Product Change Notification: P-22-023058

Modular jack connector

Change from EPS Tray to PET Tray

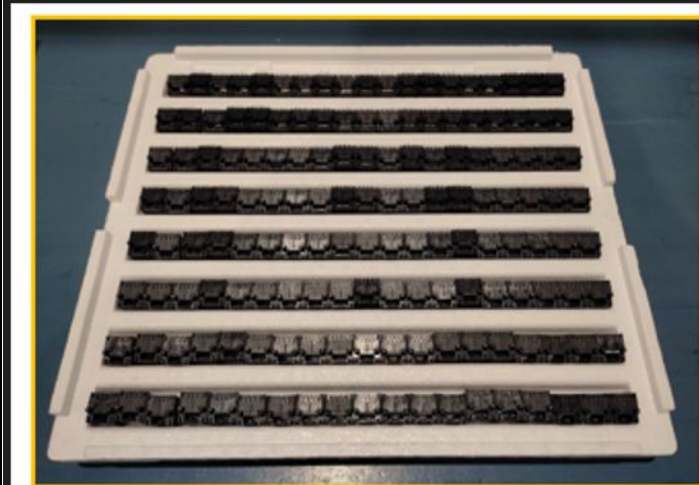
current package

new package

Product improvement.To Improve packaging efficiency and improve and address the complaints for the contacts damage and deformation

Photo

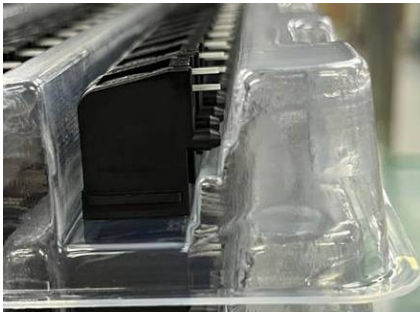
Pkg method: 138 pcs/Tray x6 =828 shipping box
 The detail packaging instruction is according to PS107-107769 Rev A.
---Test result: There are no any products damaged and defect after drop test.
---The corner of shipping box impacted were distorted, but not damaged

Photo

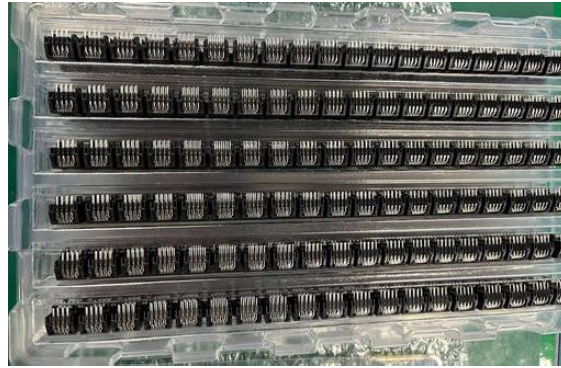
Pkg method: 114 pcs/Tray x7 =798 shipping box
 The detail packaging instruction is according to PS 107-107768 Rev A.
---Test result: There are no any products damaged and defect after drop test.
---The corner of shipping box impacted were distorted, but not damaged
